Model: NAD 30S/30/40 Bridge Unit		Date: 15-Nov-99	No.: MA688001
Modified Article: Base: Bridge Unit		Prepared by: E. Fukuyama	
From: Technical Service Dept., GTS Division			
Reason for Modification:	<input type="checkbox"/> Parts catalog correction <input type="checkbox"/> To facilitate assembly <input type="checkbox"/> Part standardization	<input type="checkbox"/> Vendor change <input type="checkbox"/> To improve reliability <input checked="" type="checkbox"/> Other	<input type="checkbox"/> To meet standards (      )

Model: NAD 30S/30/40 Bridge Unit		Date: 30-Nov-99	No.: MA688002
Modified Article: Spring Plate and Grounding Wire		Prepared by: M. Kitajima	
From: Technical Services Dept., GTS Division			
Reason for Modification:	<input type="checkbox"/> Parts catalog correction <input type="checkbox"/> To facilitate assembly <input type="checkbox"/> Part standardization	<input type="checkbox"/> Vendor change <input checked="" type="checkbox"/> To improve reliability <input type="checkbox"/> Other	<input type="checkbox"/> To meet standards (      )

Model: NAD 30S/30/40 Bridge Unit		Date: 28-Dec-00	No.: MA688003
Modified Article: Gear - 21Z		Prepared by: E. Fukuyama	
From: Technical

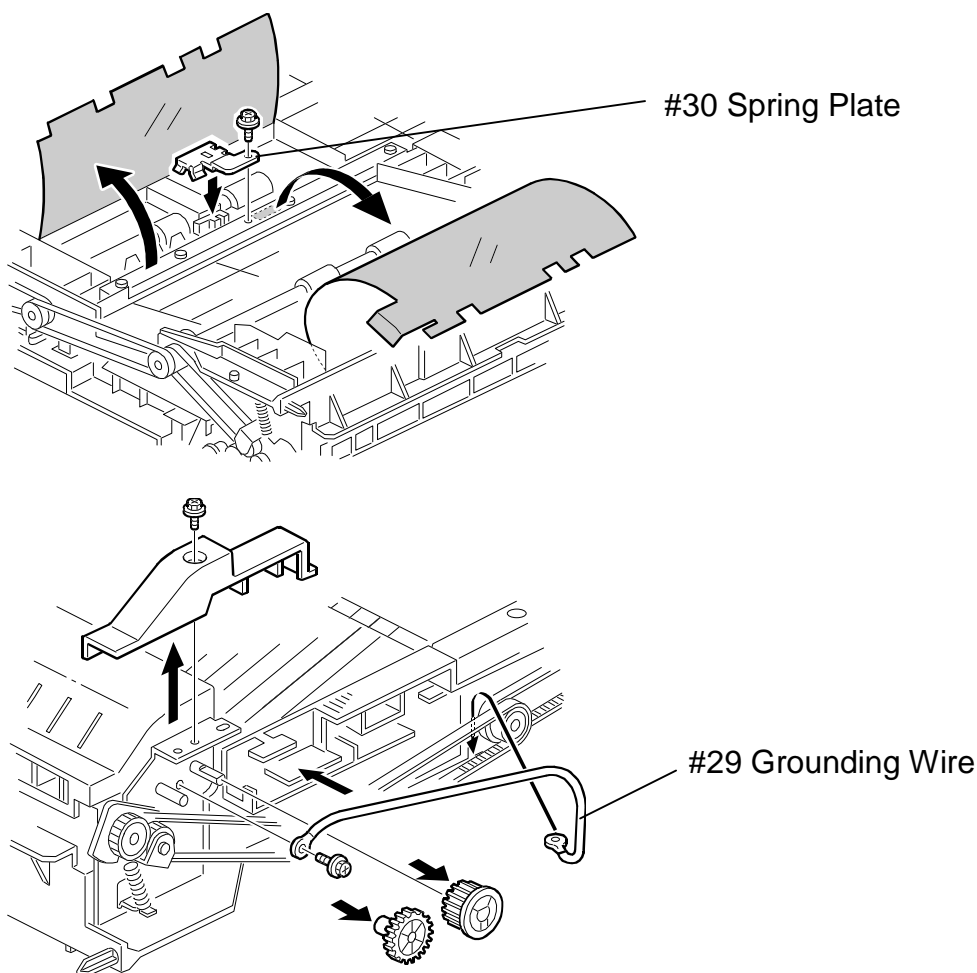
To reduce the occurrences of paper jams caused by static electricity buildup, the parts listed above have been added to the bridge unit as shown in the illustration below.

Old part number	New part number	Description	Q'ty	Int	Page	Index	Note
	A2845510	Grounding Wire	0-1	-	5	*29	* New Index
	A6883914	Spring Plate	0-1	-	5	*30	* New Index

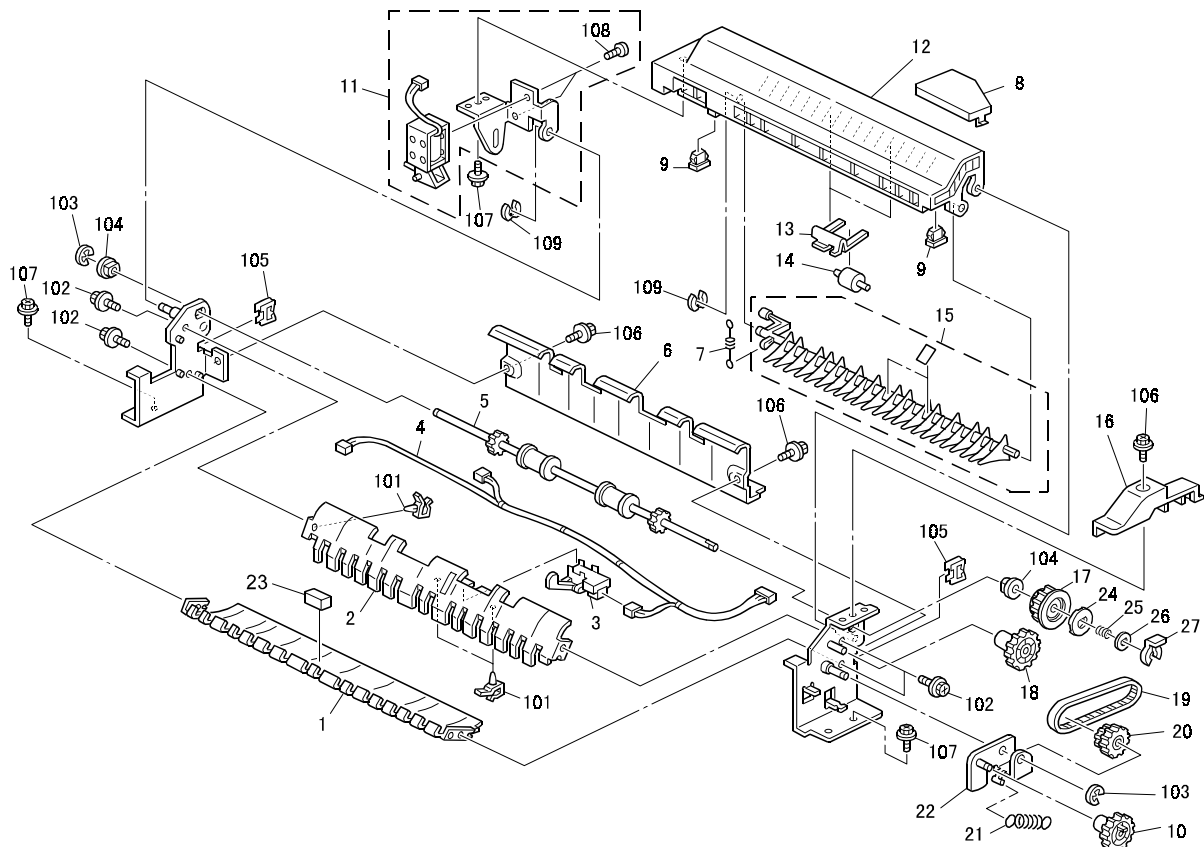
If an object gets caught between the exit rollers and exit cover, this can cause damage to both the object itself and the drive gear. To ensure that damage does not occur, a torque limiter has been added to the drive gear.

Old part number	New part number	Description	Q'ty	Int	Page	Index	Note
AB014056	AB014174	Gear – 21Z	1-1	X/X	3	17	*1
-	A6884473	Disk : Torque Limiter	0-1	-	3	24	*1
-	AA063332	Pressure Spring	0-1	-	3	25	*1
-	A6884474	Spacer : T=2	0-1	-	3	26	*1
-	08050097	Ring Separator	0-1	-	3	27	*1
